RA-21-0316
December 15, 2021

Subject: Duke Energy Carolinas, LLC (Duke Energy)
Oconee Nuclear Station (ONS), Units 1, 2, and 3
Docket Numbers 50-269, 50-270, 50-287
Renewed License Numbers DPR-38, DPR-47, DPR-55
Subsequent License Renewal Application Supplement 3

Enclosure: Index of Attachment Topics Involving SLRA Supplement

SLRA Figure 2.1.3-1

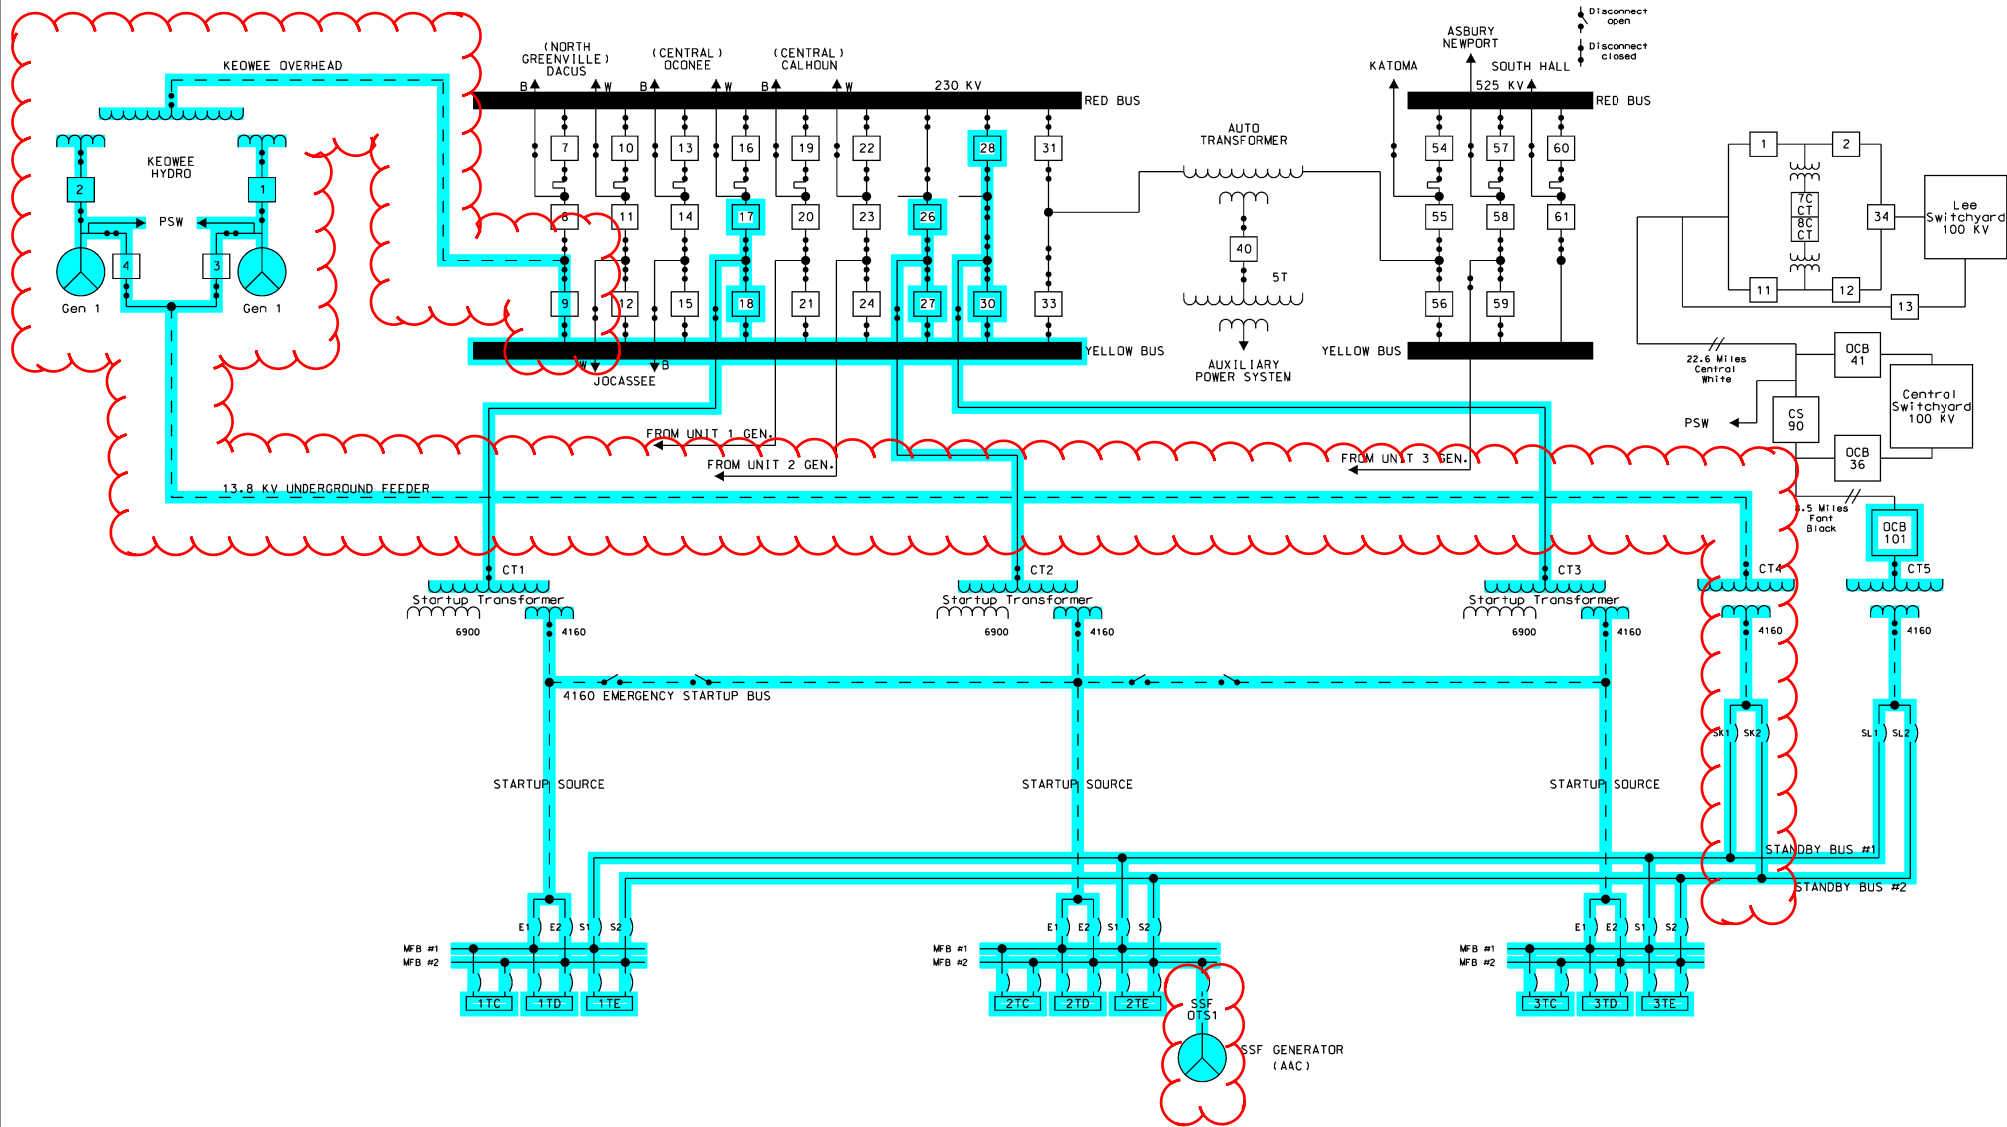
Description of Changes:

This Supplement revision of SBO Recovery Path Figure 2.1.3-1 expands the internal title and the blue highlighting of a portion of the circuits to include the Safety-Related onsite power system and Alternate AC source. The Figure legend is revised to denote that blue highlighting indicates in the scope of SLR. Changes to the figure are indicated by red cloud. A sentence referring to the Figure legend in Section 2.1.3.4 is deleted since the revised Figure legend is self-explanatory.

SLRA Section 2.1.3.4 (page 2-12) is revised as follows:

See [Figure 2.1.3-1](#) for a simplified electrical diagram of the offsite and onsite power sources, switching stations (switchyards), plant electrical distribution systems required for SBO recovery and the alternate AC source (standby shutdown facility). The 230 kV and 525 kV switchyards have two electrical buses designated as Red and Yellow. PCBs connect the two buses in a breaker-and-a-half configuration to allow removal of a PCB from service without deenergizing the circuit. ~~The blue highlighting indicates Station Blackout recovery paths.~~
